Appendix N

Comments and Responses

**Final Environmental Assessment and Section 4(f) Determination
Proposed Improvements 2016-2020 at BWI Marshall Airport**

Draft Environmental Assessment and Draft Section 4(f) Determination Proposed Improvements 2016-2020 at BWI Marshall Airport
Public and Agency Comments

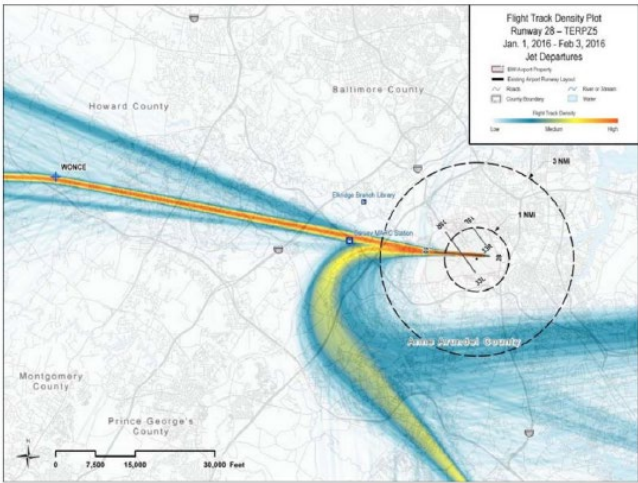
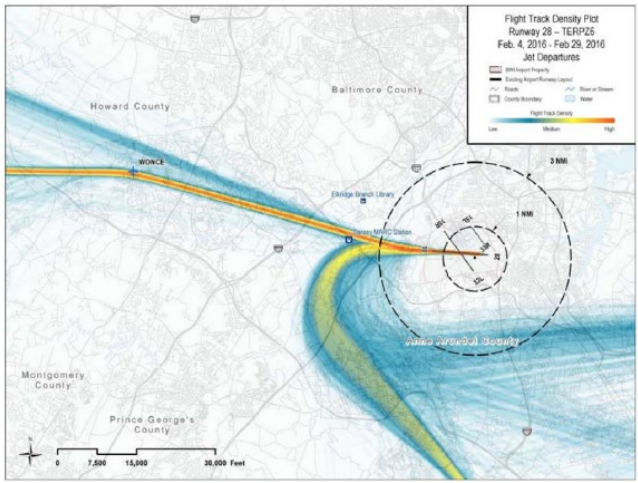
| # | Reviewer | Date | Page/Section | Comment | Response | Status |
|---|-----------|---------|--------------|---|--|------------|
| 9 | Drew Roth | 1/30/18 | Noise | <p>2. The noise contours in Appendix K do not reflect the actual flight paths under Nextgen.</p> <p>Prior to Nextgen, departures from Runway 28 proceeded straight on a line with the runway.¹</p> <p>(¹ Presentation to FAA Roundtable July 2017 http://maacommunityrelations.com/_media/client/anznoiseupdate/2017/20170718_Roundtable_Presentation_HMMH.pdf)</p> <div data-bbox="1112 816 1728 872" data-label="Caption"> <p>Jet Departures, April 2014</p> </div> <div data-bbox="1112 897 1728 1360" data-label="Figure"> </div> <p>This pre-Nextgen flight path is consistent with the noise contours in the proposal. Specifically, note that the westernmost point of the noise contours are on a straight line from Runway 28. However, under the Nextgen TERPZ 5 and TERPZ 6 procedures, there is a right turn soon after departure.</p> | <p>Both TERPZ 5 and TERPZ 6 were modeled in the Existing Condition, No Action, and Proposed Action Alternatives, which result in the noise contours turning slightly to the north. Specifically, on February 4th, 2016, departure procedure TERPZ5 was changed to TERPZ6 by the FAA. This change affected jet departure flight tracks from Runway 15R making right turns to the west and northwest as well as Runway 28 making a slight right turn towards west and northwest. For future conditions, tracks reflective of the TERPZ6 procedure were applied to the noise analysis. Figure K-1, in Appendix K of the BWI Marshall EA illustrates the TERPZ flight tracks before and after the procedure change.</p> <p>Additionally, Appendix K provides a comparison of the BWI EA 2020 Proposed Action noise contours and the Part 150 Study 2019 noise contours, see specifically Figure K-8. The most significant increase is expected to occur to the northwest of the airport between Runway 10 and Runway 15R. Areas to the southeast of the airport along the Runway 15R/33L extended centerline are also expected to experience an increase of noise level. This comparison provides clear evidence that procedural changes brought about by FAA change to the TERPZ procedure were included in the noise analysis for the BWI Marshall EA.</p> | No change. |

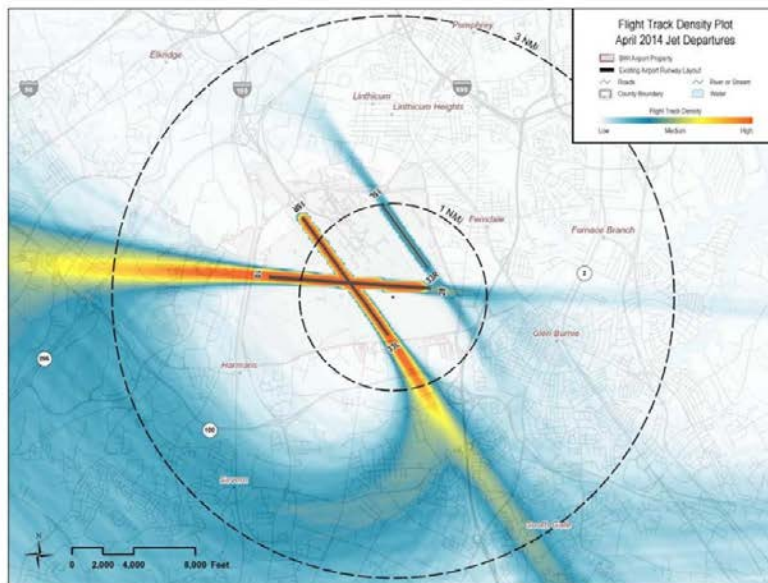
This increase in flights will necessarily increase noise in the communities surrounding the airport. This is reflected in Figure K7.

However, Figure K-7 shows the noise contour for the proposed action and the no action alternative to be nearly identical. This cannot be reconciled with the Statement of Purpose and Need, which clearly states “The Proposed Action includes those improvements required to accommodate the projected activity levels through 2020.”

If the proposed action is required to accommodate projected activity levels, there should be a difference in the noise contour between the proposed action and the no action alternative.

TERPZ5, Runway 28

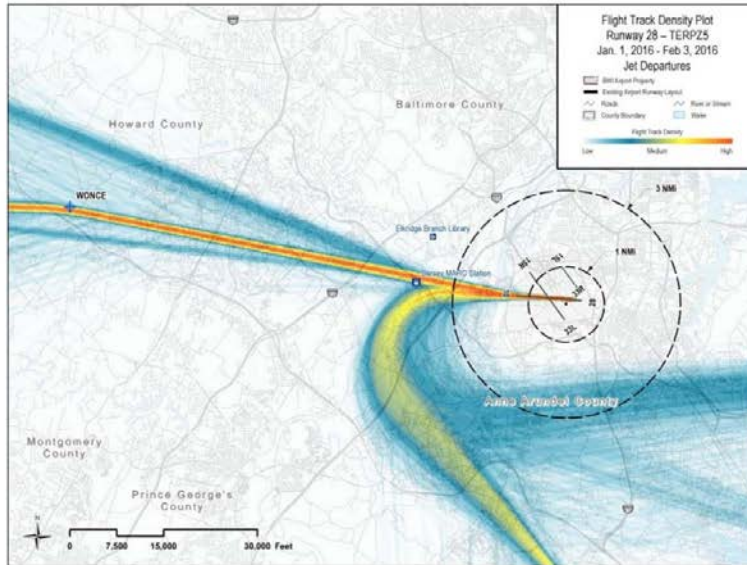
However, under the Nextgen TERPZ 5 and TERPZ 6 procedures, there is a right turn soon after departure.
